Meeting Date: September 26, 2022

Project Name: River Park

Case Number: MDP22-0002

Application type: Conceptual Master Development Plan

Sheet 4 of the MDP Showing Blocks and Anticipated Uses

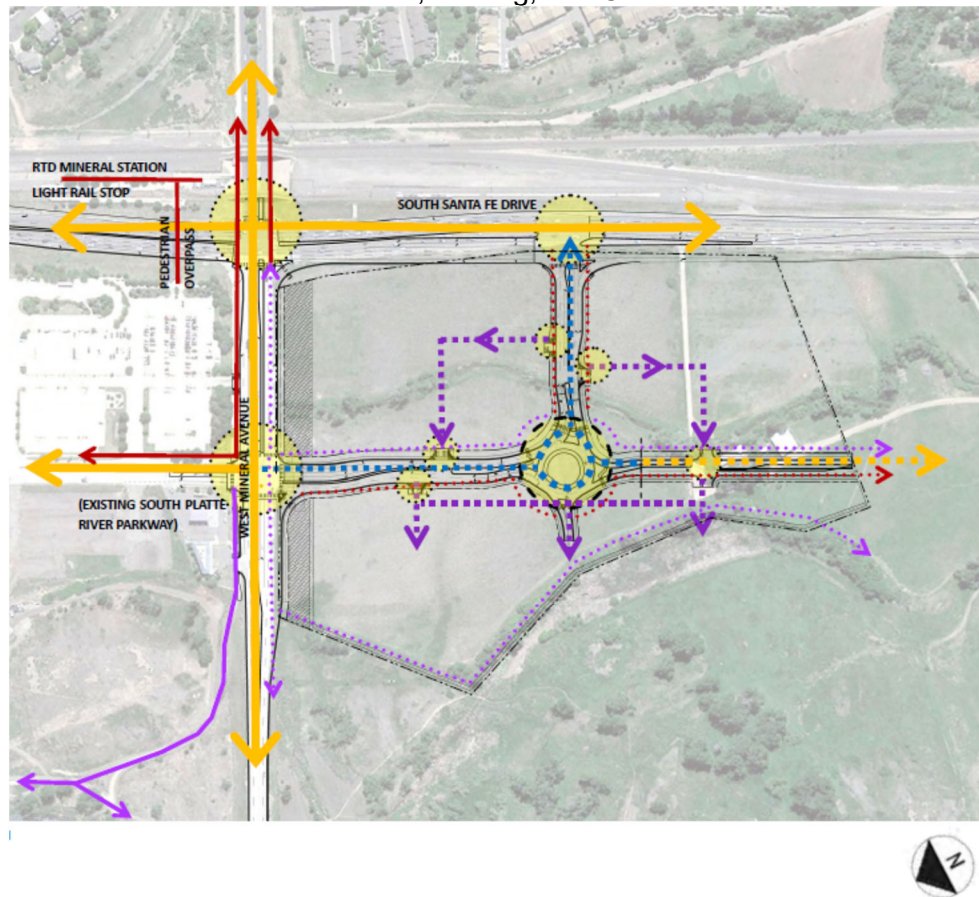
In order to be efficient, the lot layout and land uses must be designed to take full advantage of the proposed roadway network. Staff believes the blocks and land uses described in the RiverPark MDP are efficient in their layout. As shown on sheet four (see page five of the staff report), all blocks allow commercial and mixed-use development and blocks two, three, and four allow residential (multi-family use). The largest blocks (blocks one, two, and three) have the greatest exposure to either S. Santa Fe Drive or W. Mineral Avenue and provide opportunity for significant commercial

Compliance with the LCC and the Unified Land Use Code are noted several times in the proposed RiverPark MDP. The development data shown on sheet four most directly addresses how the development will comply with the Commercial Mixed zoning district and any additional restrictions provided through the MDP.

The development data on sheet four contains some errors in the maximum density for mixed-use and residential development that were corrected in the LCC shortly after the final review of this development. Mixed use developments have a maximum density of 60 dwelling units per gross acre (instead of 85 as shown in the MDP), and residential developments have a maximum density of 62 dwelling units per gross acre (instead of 75 shown in the MDP). In order to eliminate any confusion, these density numbers should be corrected in the MDP and appropriate conditions appear in the proposed resolution. With the conditions shown in the proposed resolution, the proposed MDP is sufficient to meet the zoning district conformance decision criteria.

1. In the development data on sheet four, the density of mixed-use development shall be corrected from 85 DU/Acre Max with Sustainability increases to 60 DU/Acre Max with Sustainability increases; and
2. In the development data on sheet four, the density of residential development shall be corrected from 75 DU/Acre Max with Sustainability increases to 62 DU/Acre Max with Sustainability increases.

Commercial Design Illustrative

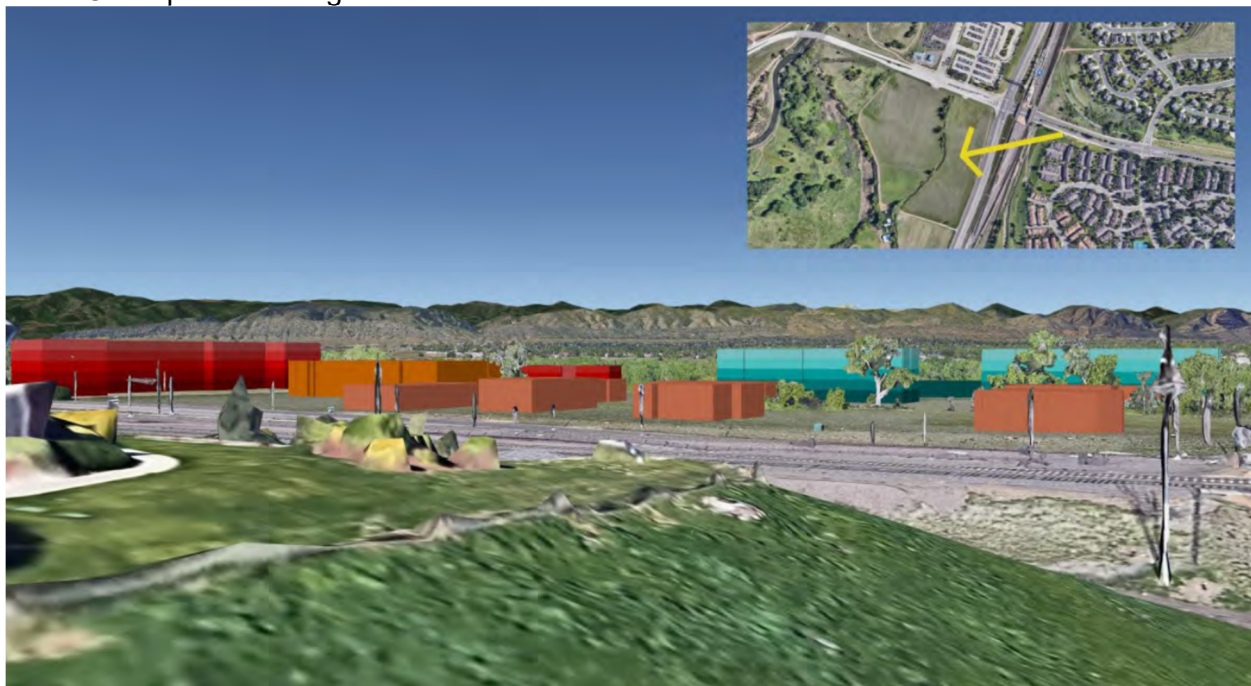
Architecturally, the RiverPark design theme is a “modern agrarian or contemporary agrarian” motif described on sheets four and in illustratives on sheet seven. Although very general and conceptual in nature, the level of quality and architecture described in the proposed MDP give city staff and future site plan applicants sufficient guidance and direction to apply the design and architectural requirements of the Littleton City Code.

Conceptual Massing Illustrative as Shown from Mineral Avenue East of Santa Fe Drive

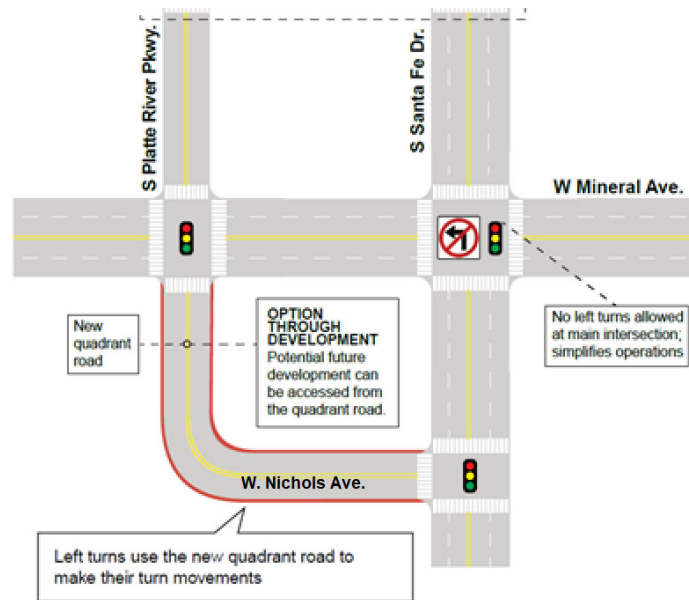
Most significantly, the MDP will limit the height of commercial and mixed-use buildings from 80 feet allowed within the district (91 feet with sustainability incentives) to 65 feet maximum. The applicant provided a conceptual massing and height illustrative in the MDP on sheet seven
